INDESIT company

Model type:
WITL62EU

Commercial code:
F034279

n1040345: Replacement of drum lock button TL EVOII.

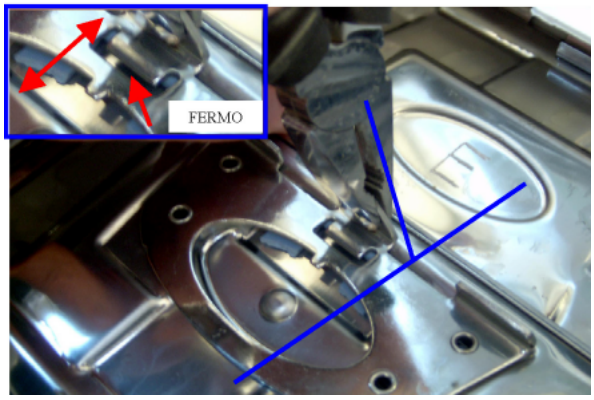
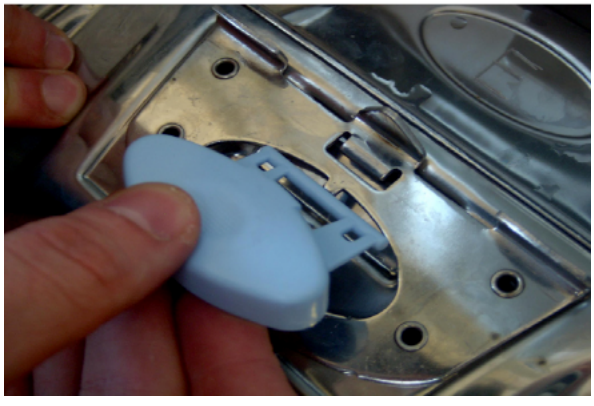
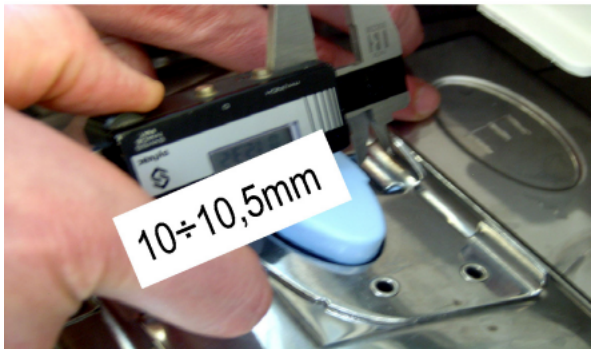
1) turn the central tip of the catch in the direction shown (FIG.1);

2) bring the tip to a vertical position and ensure that the broken button is disengaged from the catch restraint and can be removed (FIG.2);

3) remove the remaining part of the button with the aid of a screwdriver, taking care not to scratch the doors (FIG.3);

4) pre-assemble spring to button (FIG.4);

5) insert button between catch and door (FIG.5);

6) bring the button into position and arrange the spring in its location in the door (FIG.6);

7) turn the central tip of the catch in the direction shown to return it to its starting position (FIG.7);

8) check the distance between button and catch (FIG.8);

9) check correct operation of the button when opening and closing the doors (slight inclination errors of the catch can result in faulty closing of the doors) (FIG.9).

n1040382: Drain pump with bayonet-style filter - top Loading Brembate

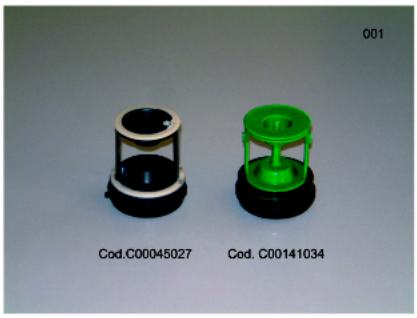
From serial no. 51021.0001 a new drain pump with bayonet-style filter has been installed on all top loading washing machines manufactured in Brembate.

New parts:
C00141862 - Drain pump
C00141034 - Pump filter kit

Premodification parts:
C00111409 - Drain pump
C00045027 - Pump filter kit

The new parts can be used instead of premodification ones.

N1040404FIG1

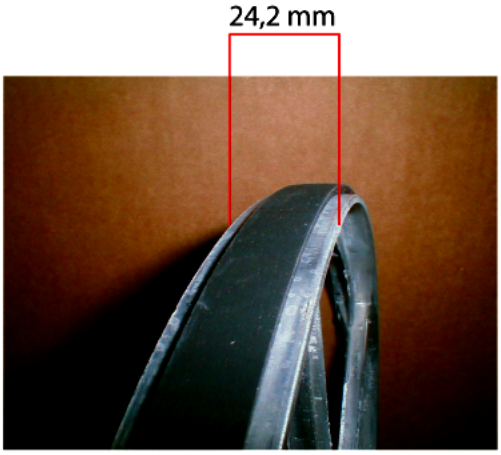
n1040404: New pulley installed on top loading washing machines up to 1000RPM (NO tub lock)

From serial no. 51202.0001 the pulley track has been widened from 21.2mm to 24.2mm (see picture N1040404FIG1).

new pulley
C00142832 - D280 24.2 mm track

Premodification pulley
C00083912 - D280 21.2 mm track

The new pulley can also be used on premodification versions of the models referred to in this release.
